petco
 PETCO ANIMAL SUPPLIES STORES, INC. 6834 WESLEY STREET GREENVILLE, TX
 PETCO "GREENVILLE, TX"
 6834 WESLEY STREET GREENVILLE, TX

DISTRIBUTION:	DATE:
75% SUBMISSION	08-11-11
98% SUBMISSION	08-16-11
100% SUBMISSION	09-23-11
PERMIT SET	09-28-11
FINAL PERMIT SET	09-20-13
BULLETIN 1	10-22-14

DRAWING TITLE:
ROOF PLAN
A2.5

ROOF PLAN	01
REF: A2.4	SOURCE: 1/8" = 1'-0"

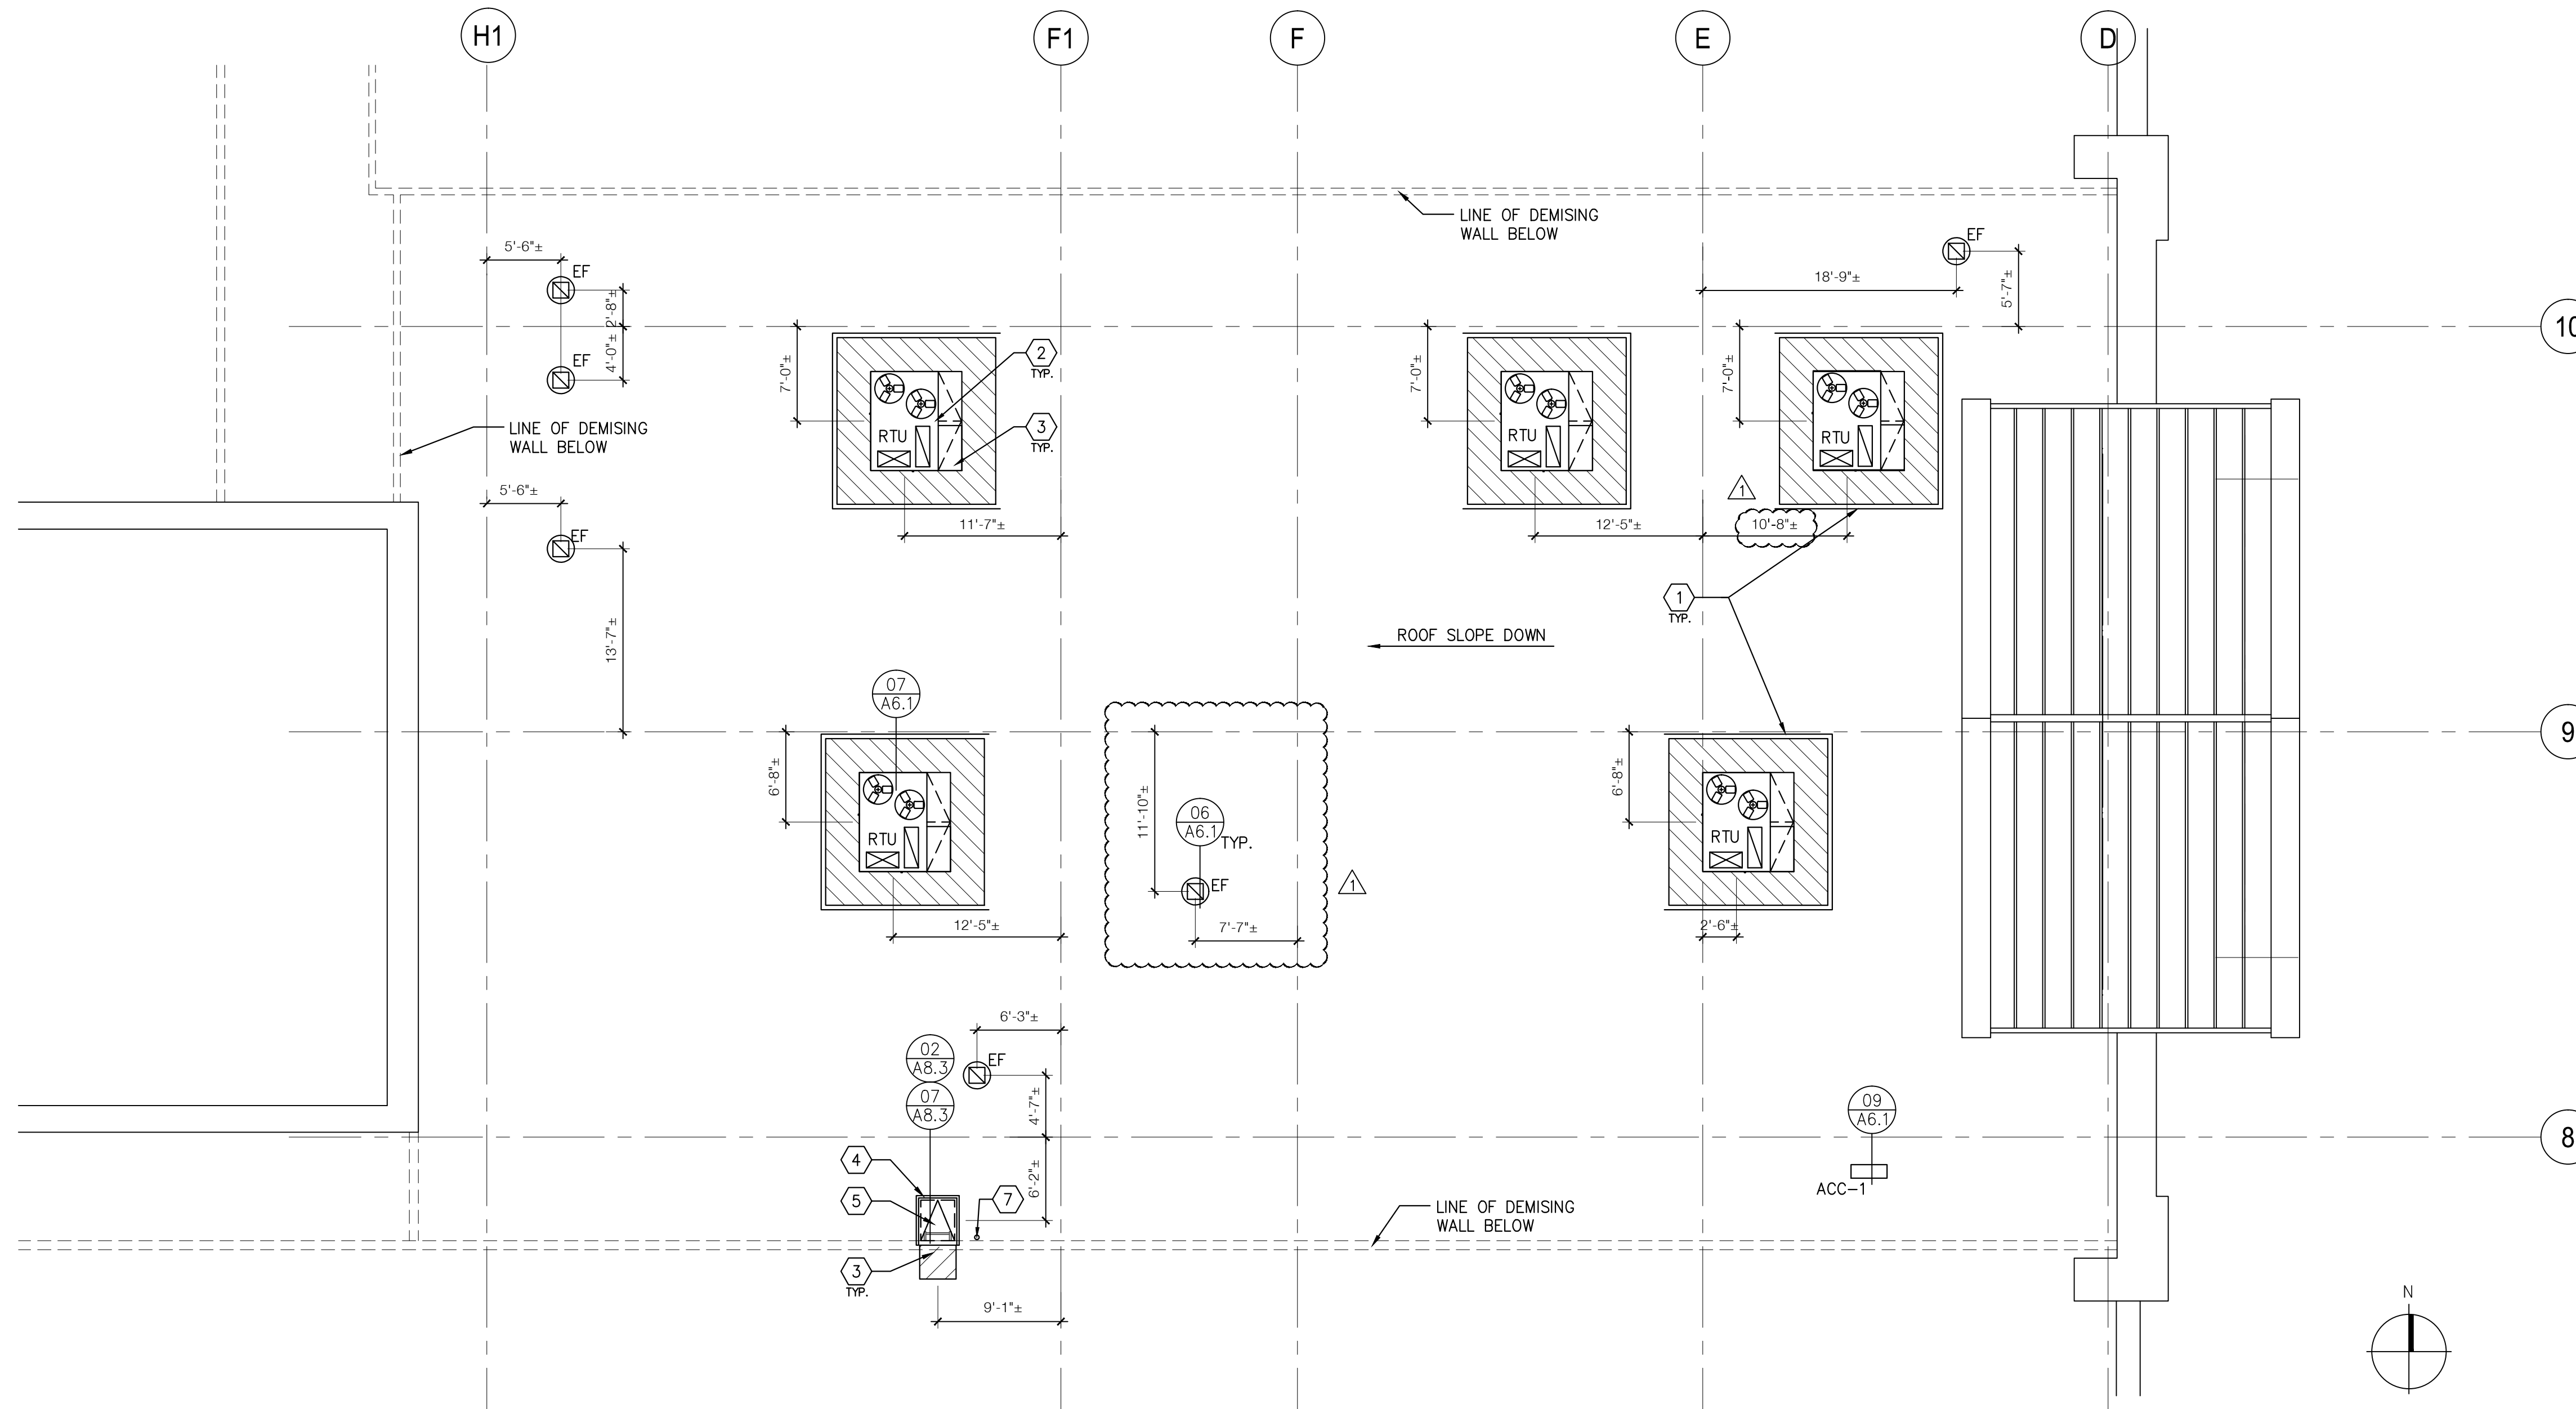
REVISED RTU LOCATION, ROOF PLAN NOTES AND KEYED NOTES. EXHAUST FAN ADDED PER PROTOTYPE.
